**STAFF REPORT
KETCHUM PLANNING AND ZONING COMMISSION
REGULAR MEETING OF SEPTEMBER 9, 2019**

PROJECT: Lofts at 660

FILE NUMBER: P19-084

APPLICATION TYPE: Design Review

1 ARCHITECTURAL SITE PLAN - OVERALL
A1.2 SCALE: 1" = 5'

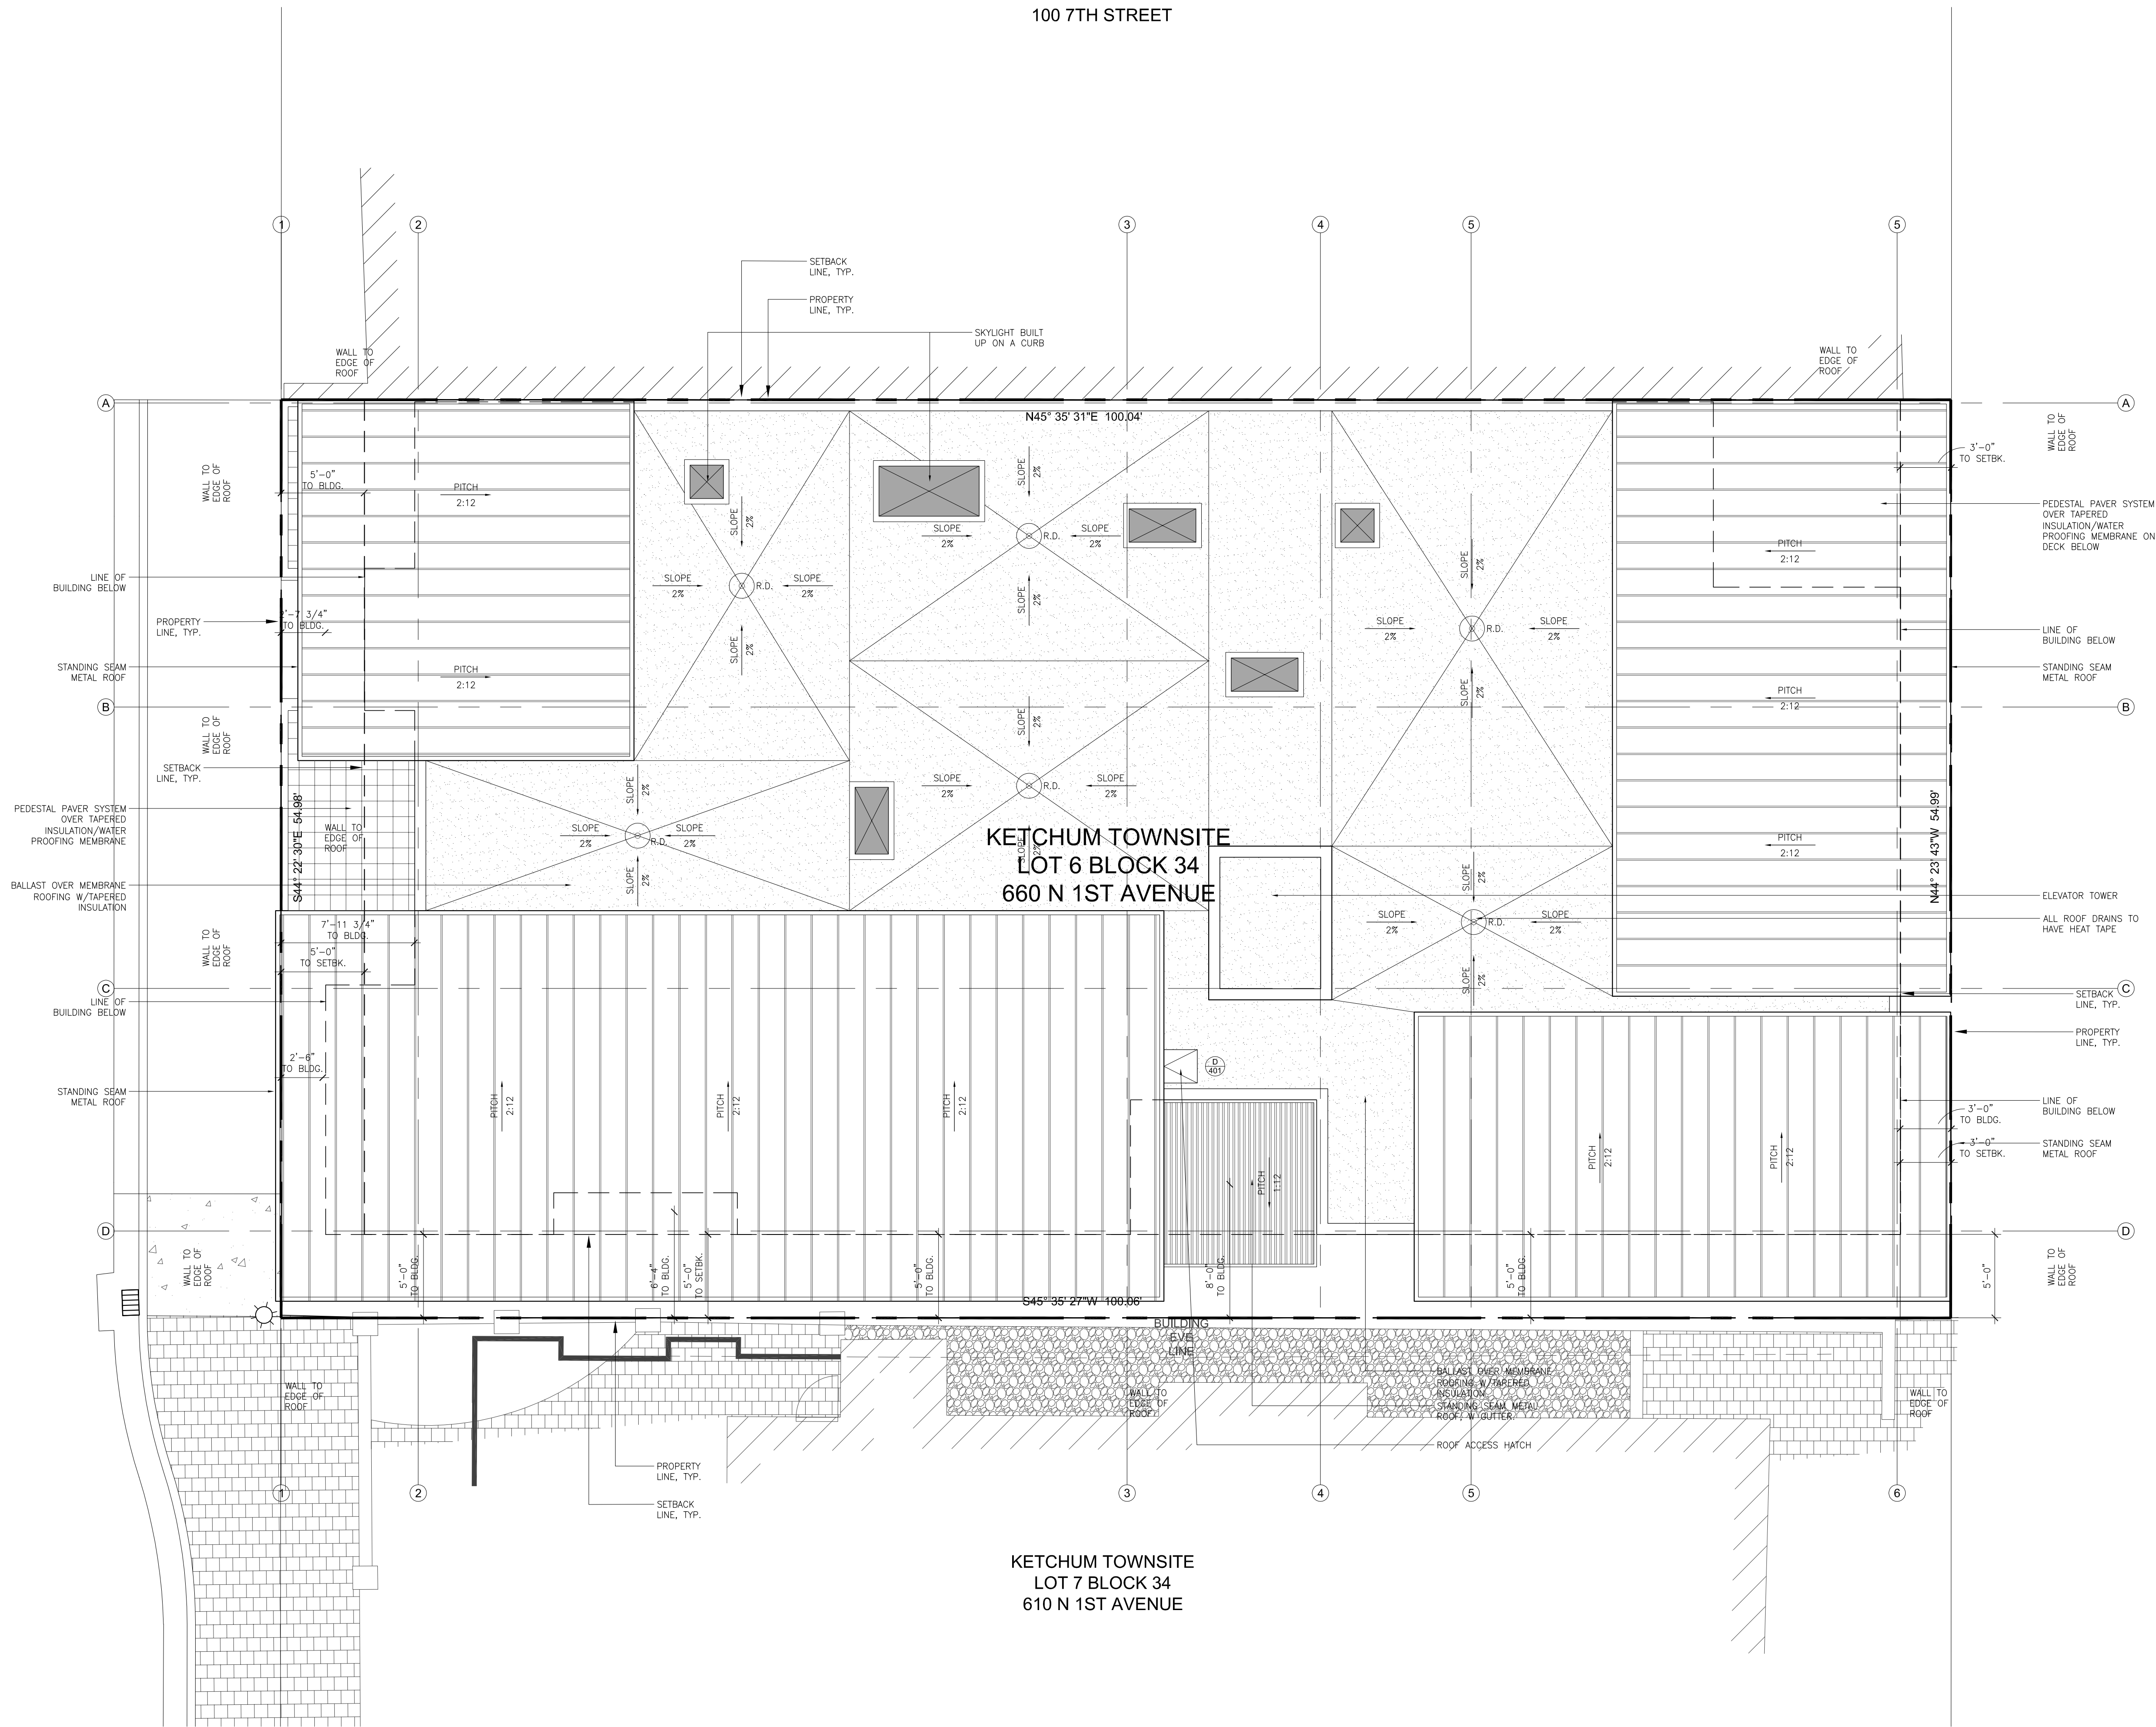
<p>The site plan indicating the setbacks of proposed multi-family residential building in relation to front, side, and rear property line is included on Sheet A1.1 of the Design Review Submittal.</p> <p>Front (1st Avenue): 5 ft average (Setback Ranges from Minimum: 2'-6" to Maximum: 7'-11¾")</p> <p>Interior Side (adjacent to existing residential development): 5'</p> <p>Interior Side (adjacent to new Sun Valley Dental Arts Building): 0'</p> <p>Rear Side Adjacent to Alleyway: 3'</p> <p>As conditioned, the project shall meet all standards for setbacks required in the CC-2 Zone.</p> <p>Cantilevered decks and overhangs: While the Architectural Site Plan (Sheet A1.2) indicates that cantilevered decks and roof overhangs are contained within the property boundaries, the south elevation (Sheet A3.1) indicates that portions of cantilevered decks at the second and third level encroach over the property line. Cantilevered decks may extend to the property line (0' setback) but may not encroach over the property line. All proposed cantilevered decks must be contained within the property boundary.</p> <p>Non-habitable structures, fixed amenities, solar and mechanical equipment affixed to the room from all building facades: The roof plan indicated on Sheet A1.2 does not include non-habitable structures or fixed amenities. Any mechanical equipment affixed to the roof shall be setback from the property lines a minimum of 10 ft.</p>

1 FIRST FLOOR PLAN
A2.1

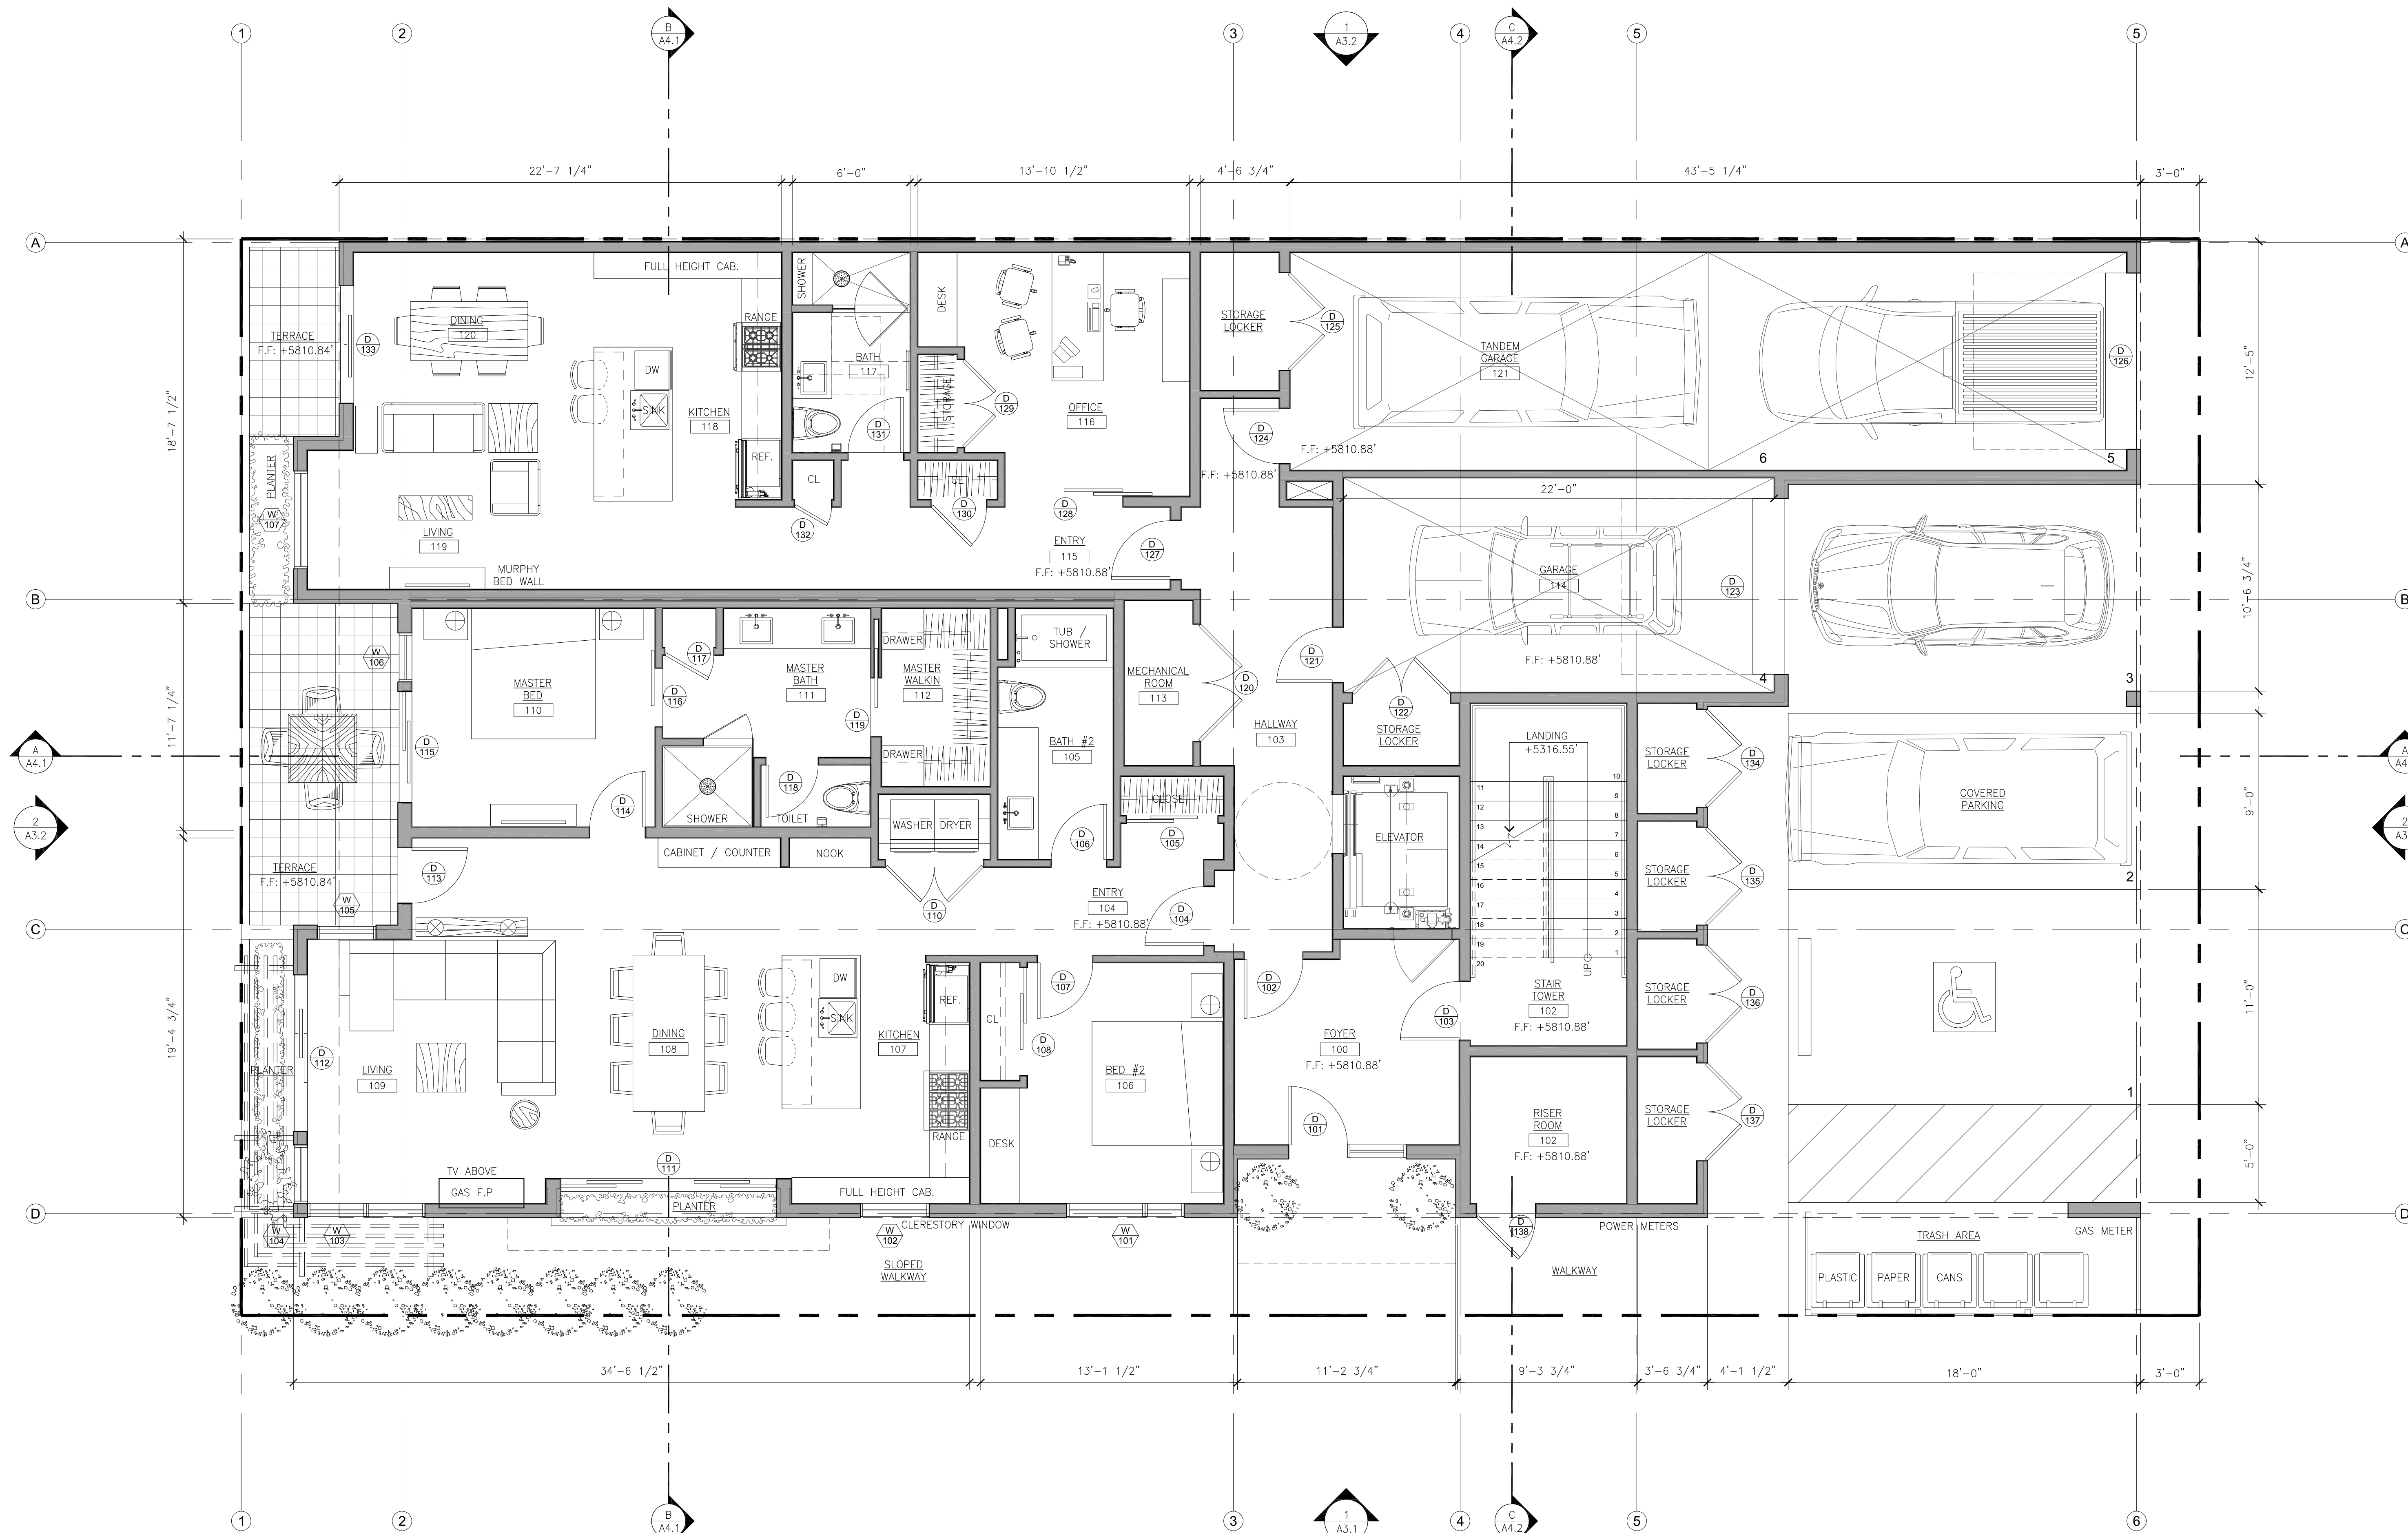
Staff Comments	As indicated on Sheet A2.1 of the Design Review submittal, the trash area is located off the alley. The south exterior building elevation indicated on Sheet A3.1 indicates that the garbage storage area will be fully screened from public view. Prior to issuance of a Building Permit for the project, the applicant shall submit a will serve letter from Clear Creek Disposal to the Planning & Building Department.
<input checked="" type="checkbox"/>	<input type="checkbox"/>	<input type="checkbox"/>	17.96.060(F)(8)	Building design shall include weather protection which prevents water to drip or snow to slide on areas where pedestrians gather and circulate or onto adjacent properties.
			Staff Comments	As indicated on Sheet A1.2 of the Design Review submittal, weather protection is provided through the use of overhangs as well as a roof drain system. No roof drainage is permitted within the public ROW.
